FIRE SAFETY INSPECTION REPORT

MEDITEX INDUSTRIES LIMITED.

PLOT 912, KASHIMPUR ROAD, KONABARI, GAZIPUR

April 7, 2014

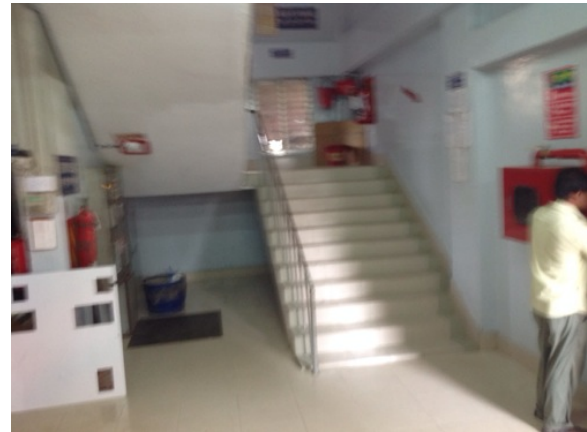
F-2	Fire Rated Construction	The boiler / generator / transformer room is not separated by fire-rated construction (openings, non-rated doors, penetrations).	Separate the boiler / generator / transformer room by a minimum 2-hr fire-rated construction. Seal and/or protected all openings to maintain the required fire separations	Within 3 months
-----	-------------------------	--	--	-----------------

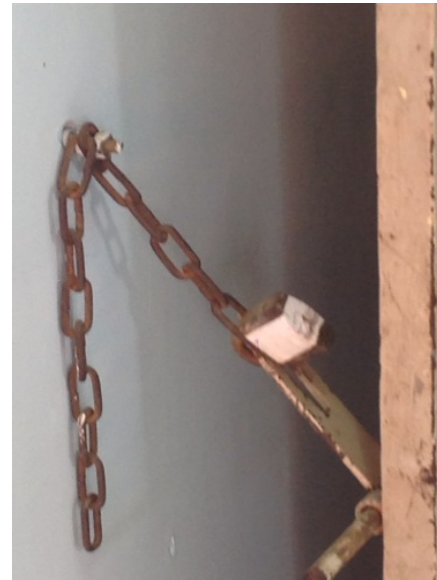
F-7	Egress	Egress doors / gates with locking features are provided at [building exits, exit stairs, along egress routes, exit discharge.	Remove locking features from all egress doors / gates. If locks are required for security reasons, utilize special door locking features complying with NFPA 101.	Immediate
-----	--------	---	--	-----------

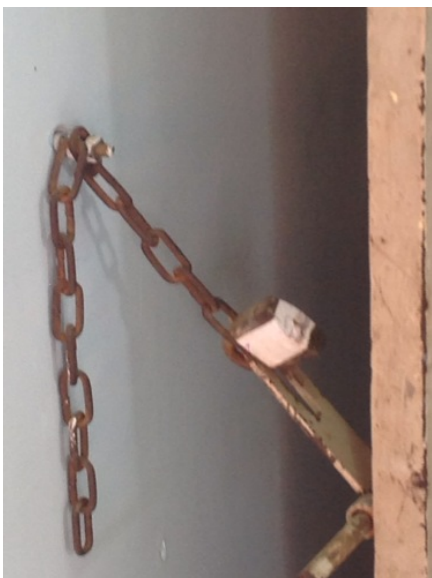
F-11	Egress	Exit stairwell doors are being locked in the open positions.	Remove locks .	Immediate
------	--------	--	----------------	-----------

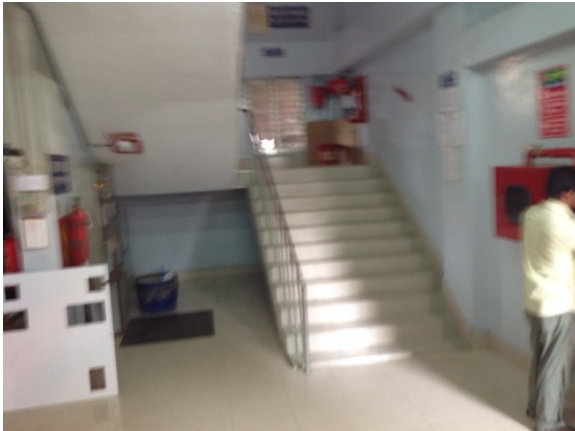
F-15	Egress	Exit stairs discharge inside the building. The south exit discharges onto the Ground floor working area,	Provide 2-hr fire-rated exit passageway leading directly outside.	Within 6 months
------	--------	--	---	-----------------
